35/13-05X 3 Primrose Street
Chevy Chase Village Historic District

HISTORIC PRESERVATION COMMISSION STAFF REPORT

Address:	3 Primrose Street, Chevy Chase	Meeting Date:	10/26/2005
Applicant:	Susan & Michael Harreld (David Jones, Architect)	Report Date:	10/19/2005
Resource:	Contributing Resource Chevy Chase Village Historic District	Public Notice:	10/12/2005
Review:	HAWP	Tax Credit:	None
Case Number:	35/15-05X	Staff:	Anne Fothergill
PROPOSAL:	Rear addition and side porch enclosure	RECOMMENDATION:	Approve with one condition

February 8, 2006
Staff Item

WEST ELEVATION - 3 PRIMROSE ST CHEVY CHASE MD
Scale 1/4" = 1'-0"

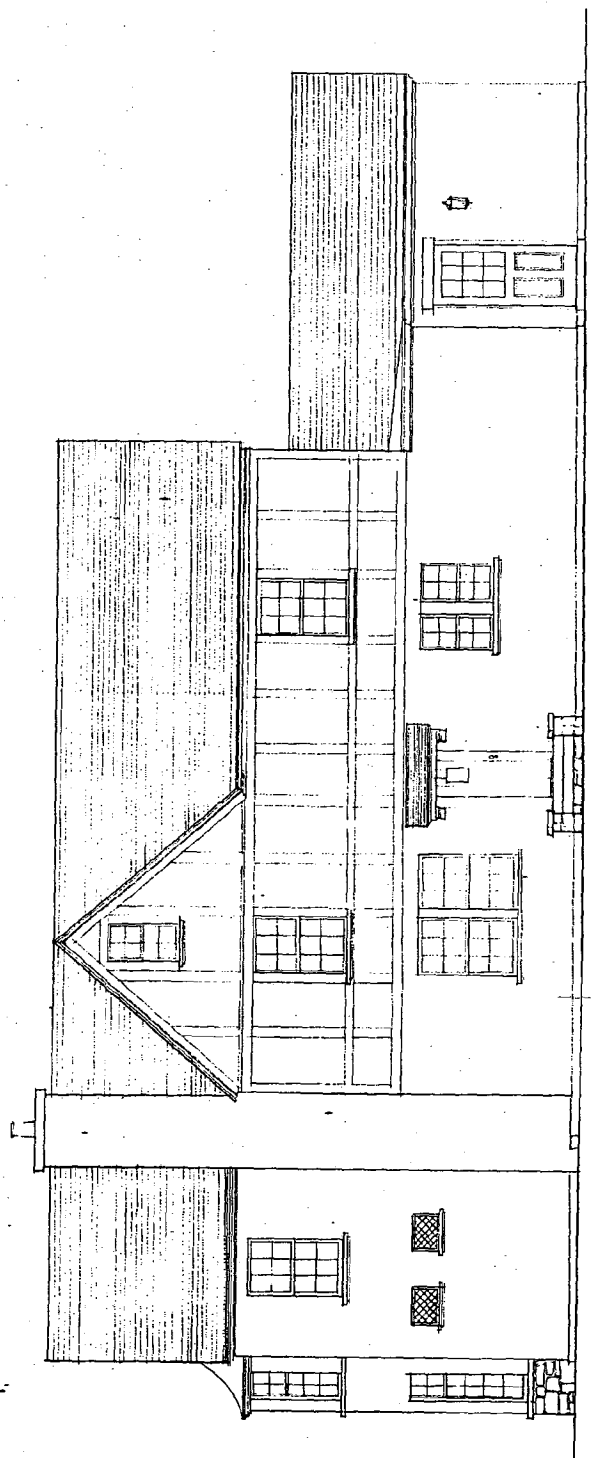
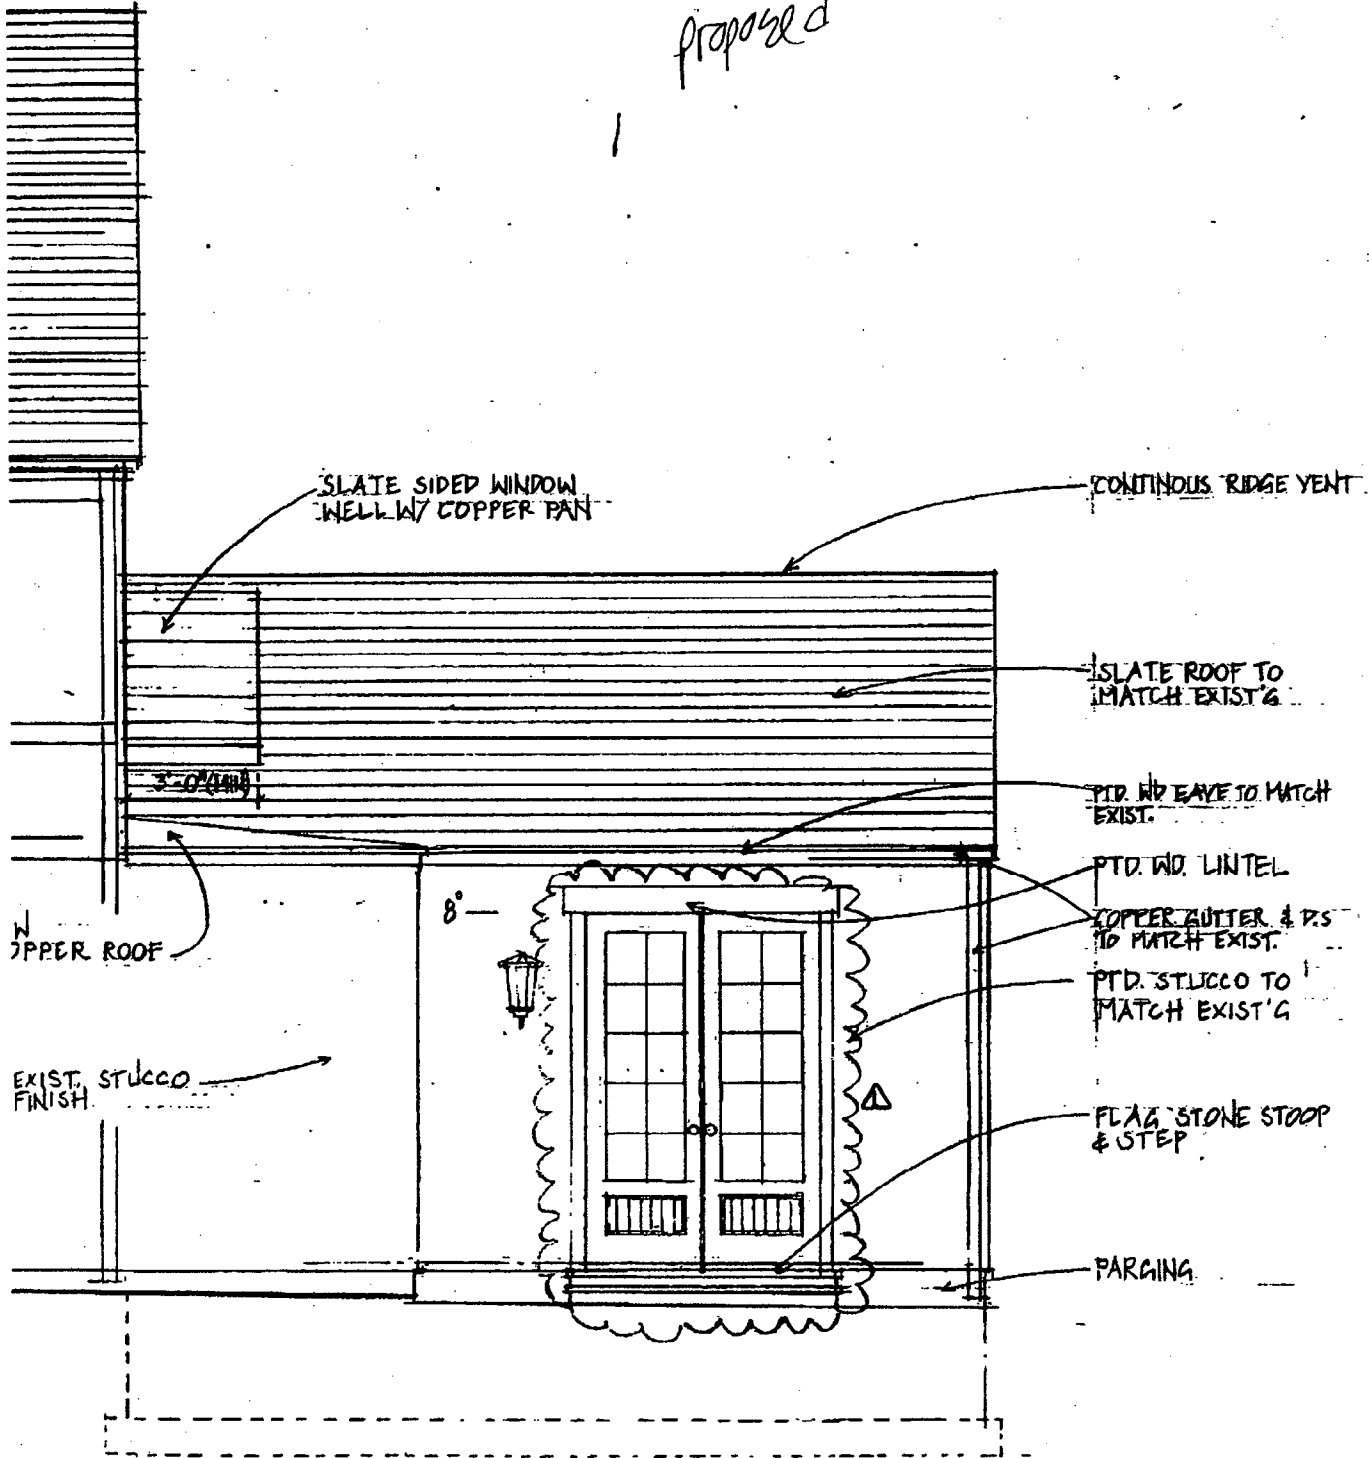
yes West side: change in doors (see Circles 4+5)

The HPC said staff can approve the submitted changes to the doors on the east and west side elevations. However, they will not allow me to stamp the changes (window removal) on the rear elevation. That proposed change would need to come back to the HPC as a HAWP revision. However, should you decide to apply for that revision, I don't think they are going to approve a blank wall there and you will need to put in some windows.

EAST ELEVATION - 3 PRIMROSE ST, CHEVY CHASE, MD
 Scale 1/4" = 1'-0"

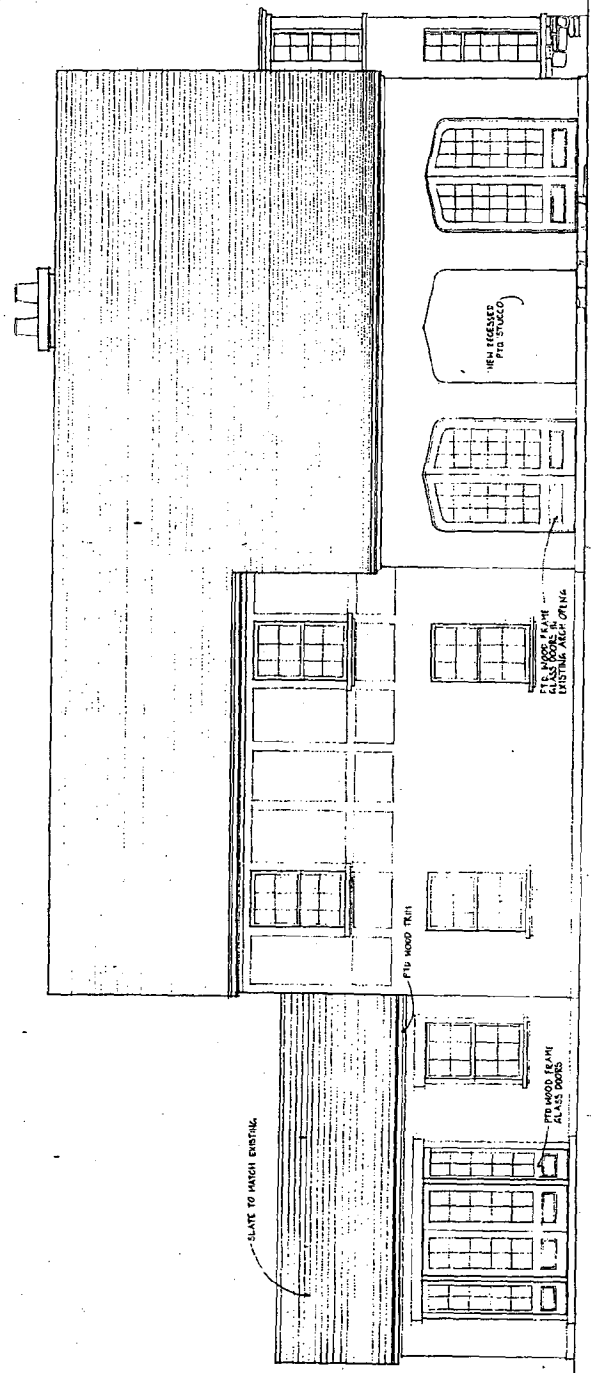
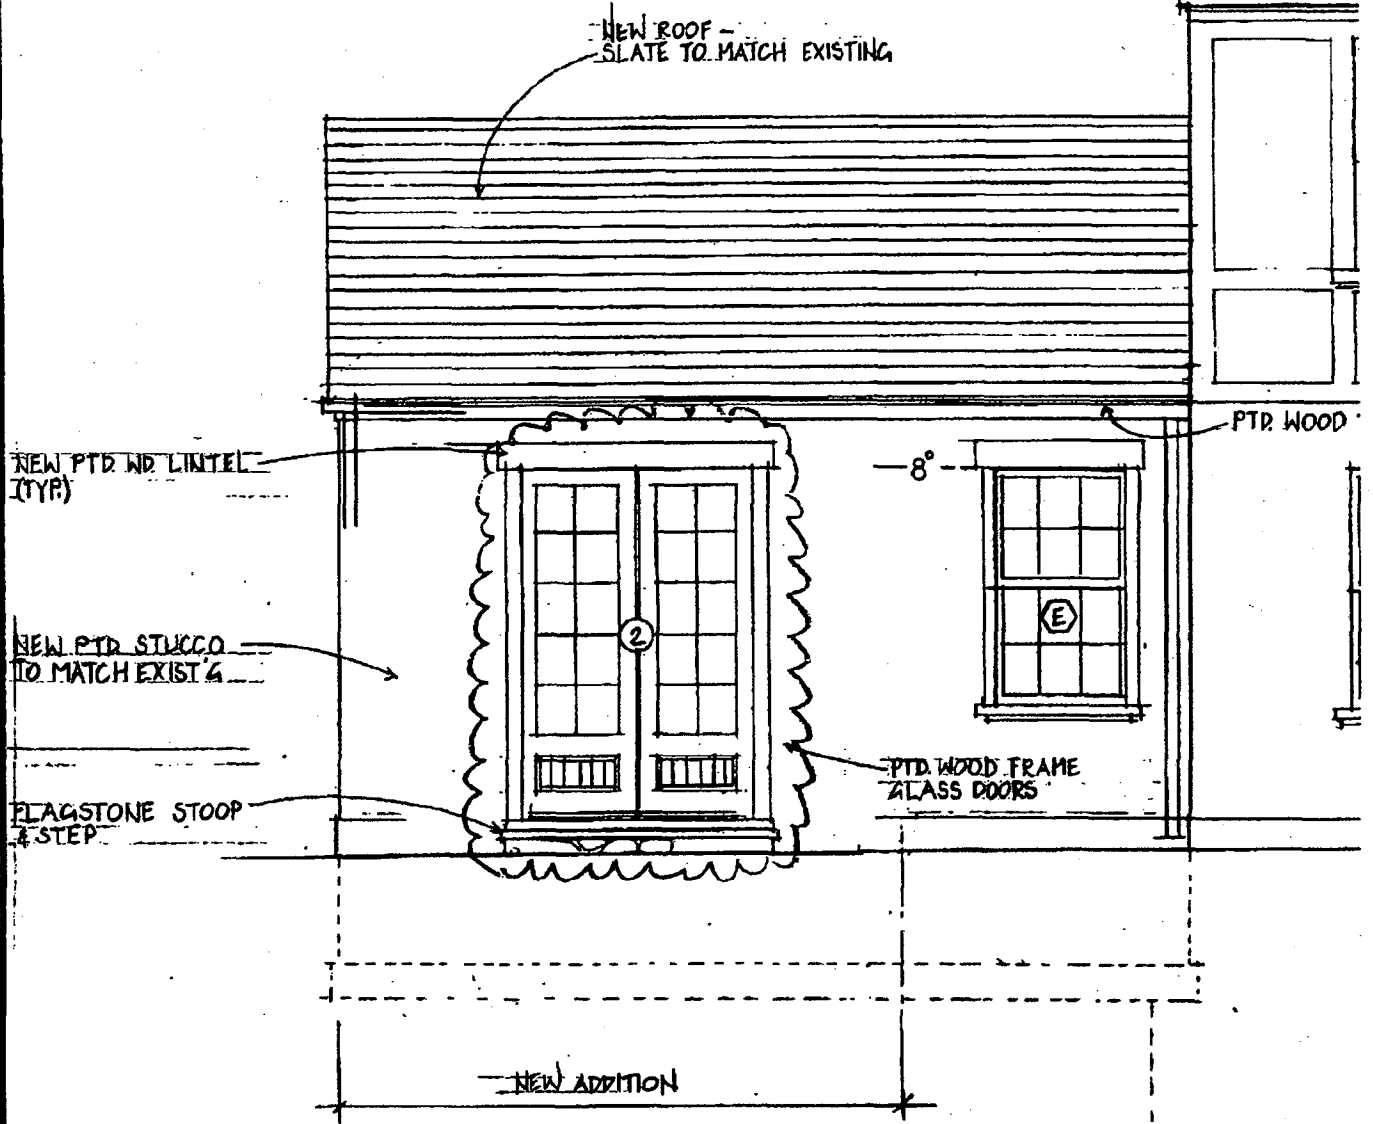
yes East side: replace single entry door with double doors to match west side (see Circles 2+3)

NORTH ELEVATION • 3 PRIMROSE ST, CHEVY CHASE MD

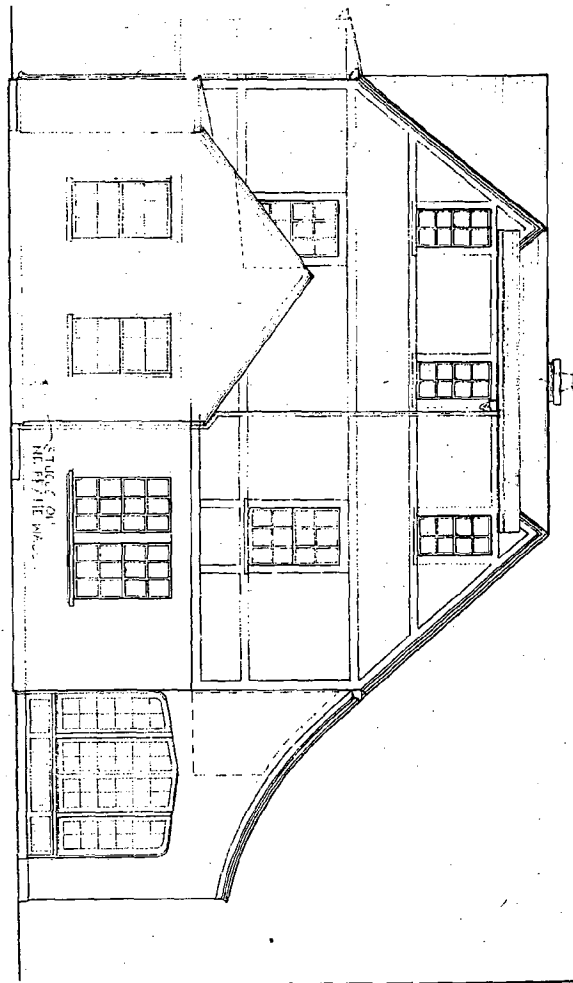
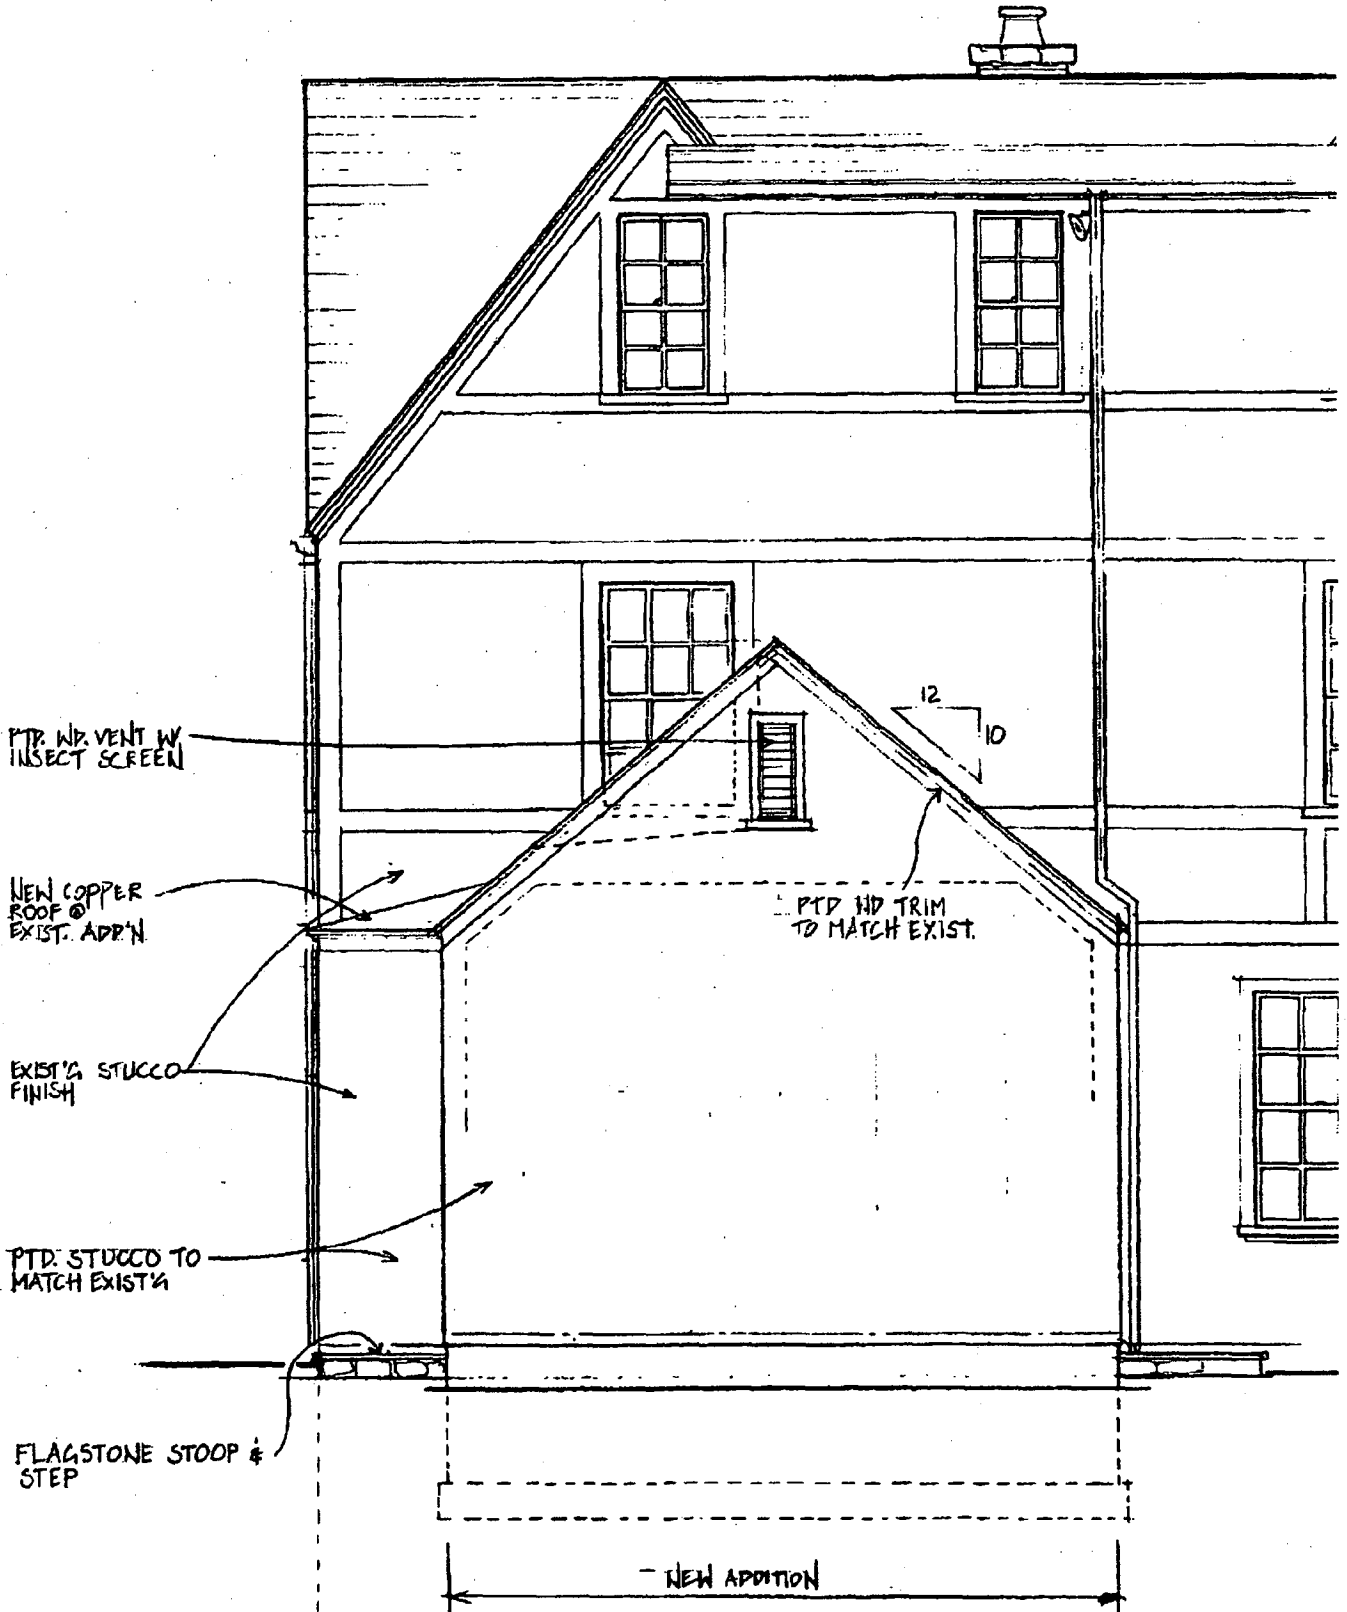
NO North side (rear): Remove two windows and infill area with stucco (see Circles 6+7)
No windows proposed because of the close proximity of the existing garage (approved site plan in Circle 8).

needs HAWP revision
